**Town of Gorham
 Planning Board Meeting
 September 12, 2022**

ITEM 1 – Public Hearing – Site Plan Amendment - Grondin Aggregates, LLC – Brandy Brook Quarry, 57 Ossipee Trail – a request for approval to include the addition of stormwater infrastructure, winter salt storage shed, stump and brush processing. Zoned R-SZ, M42 L5. The applicant is represented by Shawn Frank, P.E., with Sebago Technics, Inc.

Grondin Aggregates – Brandy Brook Quarry Site Plan Amendment
57 Ossipee Trail
M42/L5

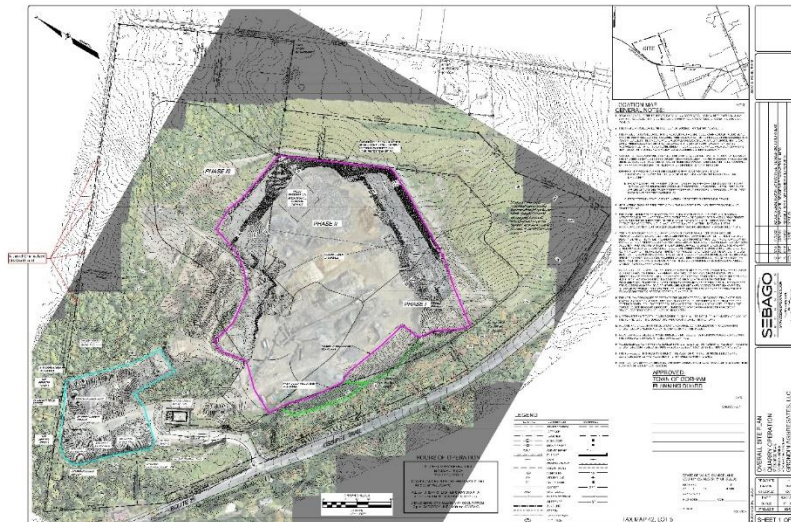
4. Comments on the stormwater analysis:
 - a. The southern boundary of the post-development drainage area does not follow the southern ridge and cuts through the quarry. The analysis should be revised to include the full post-development drainage area.

- b. The Borrow Pit and Quarry Inspection Report noted a possible unauthorized external drain location to the northwest of the stockpile area. This was noted as a deficiency resulting in off-site impacts to protected natural resources. The report also listed the possible elimination of this discharge as a corrective action item. The report also stated that the DEP requested to review the stormwater plans to determine if the discharge location is licensed. It is unclear if this information has been provided and reviewed. Applicant to provide comment, including identifying the location of the possible external drain location identified in the DEP report.

- c. It appears that stormwater runoff would flow off the northwesterly side of the site. Some channelization is seen in the topography as well. It appears that a large portion of Drainage Area 1S would drain off-site on this northwesterly side of the site instead of draining to Study Point SP-1. Both the pre-development and post-development contours appear to show this drainage pattern. Additional study points should be used in the analysis to provide a more

detailed analysis of how off-site runoff is changing as a result of the proposed project. See attached marked up plan showing the areas of concern. The additional study points should include the plunge pools, if they are discharge points.

d. Clarification be provided for 2P: Quarry Area. particular, how the invert elevation of culvert was determined to be This elevation to be lower than bottom of ponding (lowest elevation quarry is shown as on the abutter provide comment

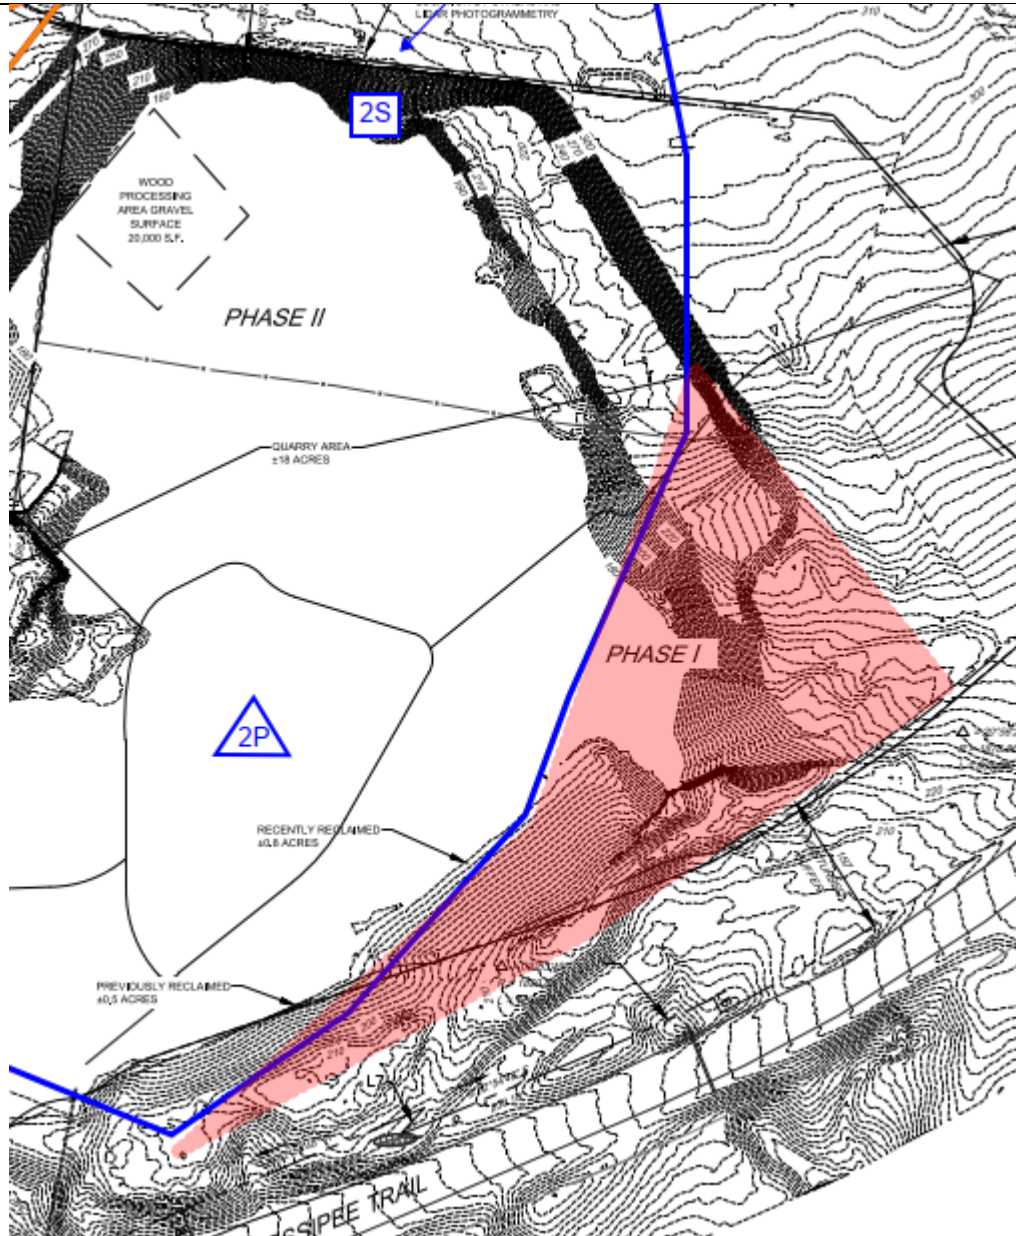
6. WP Original Comment 4a: The southern boundary of the post-development drainage area does not follow the southern ridge and cuts through the quarry. The analysis should be revised to include the full post-development drainage area.

WP Follow Up Response: The boundary of drainage area 2S, as shown on the annotated Overall Site Plan in the stormwater memo, has not been revised. The boundary does not include all of the drainage area and should extend all the way to the southern ridge as highlighted in red below. The HydroCAD model does not account for this area either. Revise both the map and model.

Applicant Response: Please see the updated stormwater narrative and accompanying watershed maps and model for the revised extent of this drainage area.

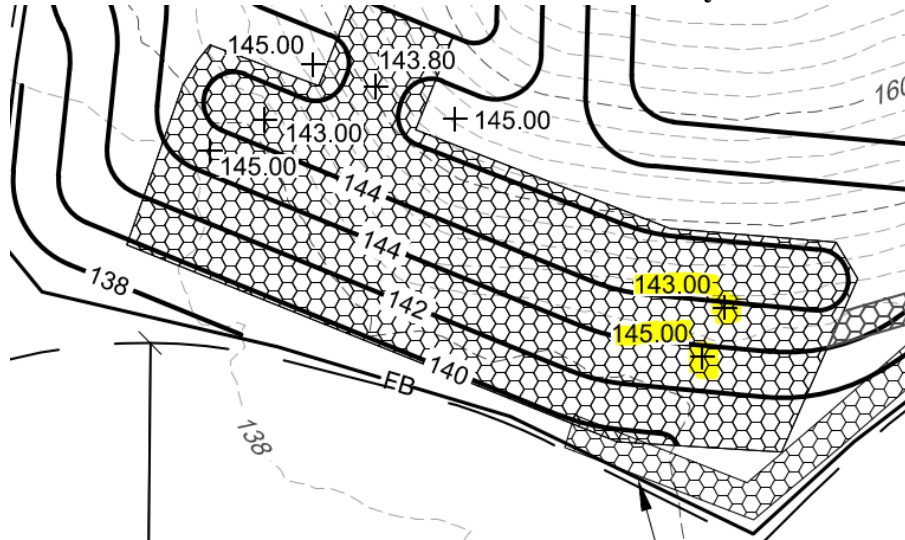
WP Follow Up Response: When available, please submit the MDEP approval to the Town. We recommend MDEP approval be a condition of site plan approval. The following comments are related to the proposed detention basin with level spreader outfall:

- a. Although the plan shows the grading of the level lip spreader, please label it on the plan as well.
- b. The spot grades highlighted in yellow below do not appear to be in the correct location. The spot grades should be corrected.
- c. The HydroCAD report shows an outlet at elevation 143.50' but this is not shown on the plans. The outlet should be shown on the plans.
- d. Erosion controls should be extended around the northerly side of the detention basin

Applicant Response: The runoff to the referenced external drain has been redirected to more closely follow the originally proposed drainage path. The revised stormwater plan consists of installing a detention basin with level spreader outfall to intercept runoff along the northerly property line. This plan will be submitted to MDEP as part of this process.

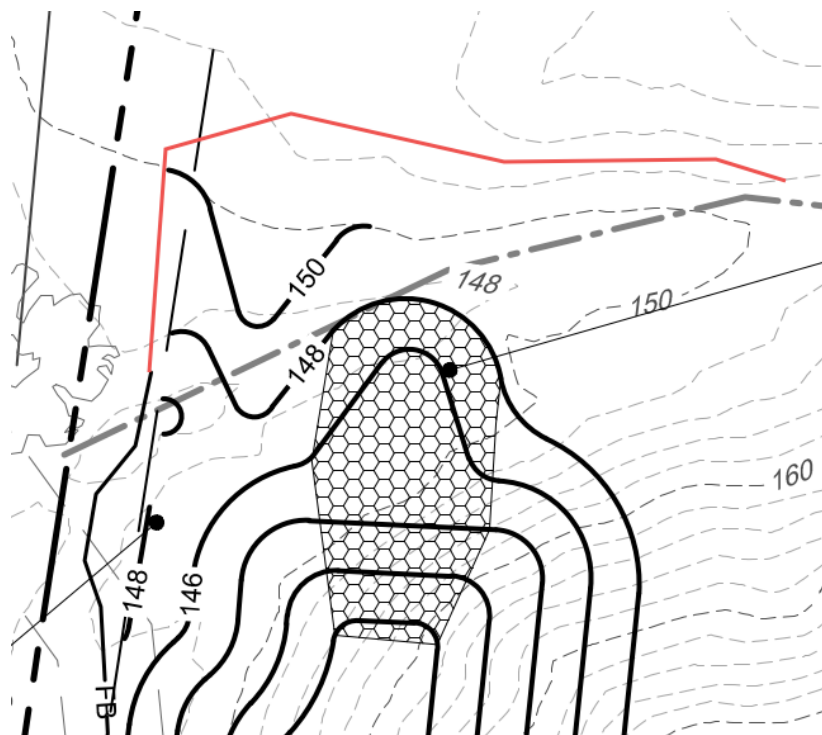
so that it is downslope of all disturbed surfaces (see approximate sketch in red below).

- e. **Have test pits or other means of determining the groundwater elevation been conducted? Adequate separation between the bottom of the detention basin and seasonal high-water table should be provided.**
 - f. **The Borrow Pit and Quarry Inspection Report states that there is a 100-foot road buffer along the westerly side of the property; and the proposed detention basin is within the 100-foot road buffer. Revise the proposed design to comply with the buffer requirements.**
8. WP Original Comment 8a: Town to provide comment on the approved quarry size.
Applicant Response: *Acknowledged.*
WP Follow Up Response: Coordinate with the Town on the quarry size. We recommend that an agreement be made to correct the situation prior to approval of the project.
